Access Compliance Report

Public Rights-of-Way (Curb Ramps)

Intersection ID: N/A	Main Street: W W T HARRIS BV	Cross Street: N/A	Location: E
ADA ID: BD5AFB7CFF67	Ramp Type: IslandPerp	Initial Pass/Fail: Fail	Overall Compliance: No
Severity Score: 13.75			
Codes/Mitigation Info/Possible Solution		Field Measurements/Component Compliance

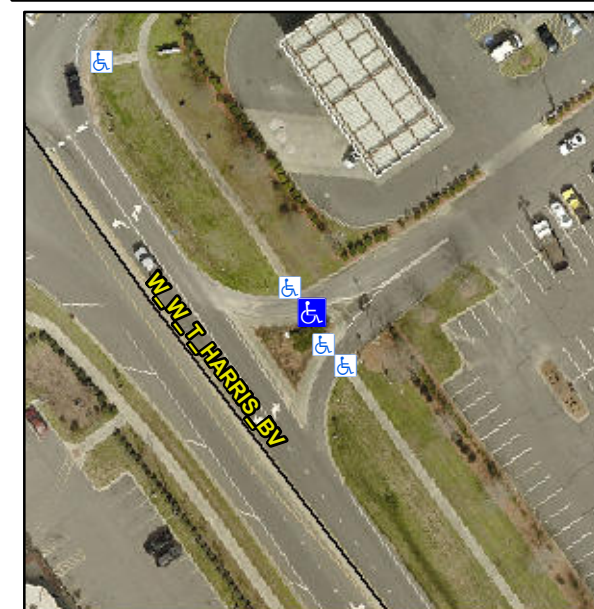
Not Found, R304.2.2

Compliance	Description	Data	Compliance	Description	Data
N/A	Ramp Length (in)	68.5	No	Ramp Slope (%)	8.7
Yes	Ramp Width (in)	68.0	Yes	Ramp XSlope (%)	5.0
N/A	Flare Type LT	N/A	N/A	Flare Type RT	N/A
N/A	Flare Slope LT (%)	N/A	N/A	Flare Slope RT (%)	N/A
N/A	Flare Traversable LT?	N/A	N/A	Flare Traversable RT?	N/A
N/A	Landing Length (in)	N/A	N/A	DWS Provided?	N/A
N/A	Landing Width (in)	N/A	N/A	DWS Contrast?	N/A
N/A	Landing Slope (%)	N/A	N/A	DWS Length (in)	N/A
N/A	Landing X Slope (%)	N/A	N/A	DWS Full Width?	N/A
N/A	Landing Curb? (Y/N)	N/A	N/A	DWS Offset (in)	N/A
N/A	Shared Landing?	N/A			
N/A	Gutter Ponding?	N/A	N/A	Gutter Slope (%)	N/A
N/A	Gutter Lip Ht (in)	N/A	N/A	Gutter X Slope (%)	N/A
N/A	Painted X Walk1?	No	N/A	Painted X Walk2?	N/A
	X Walk 1 Direction	To N		X Walk 2 Direction	N/A
N/A	X Walk 1 Width (in)	N/A	N/A	X Walk 2 Width (in)	N/A
	X Walk 1 Slope (%)	0.1		X Walk 2 Slope (%)	N/A
	X Walk 1 X Slope (%)	5.7		X Walk 2 X Slope (%)	N/A

Remove & Replace Entire Ramp.
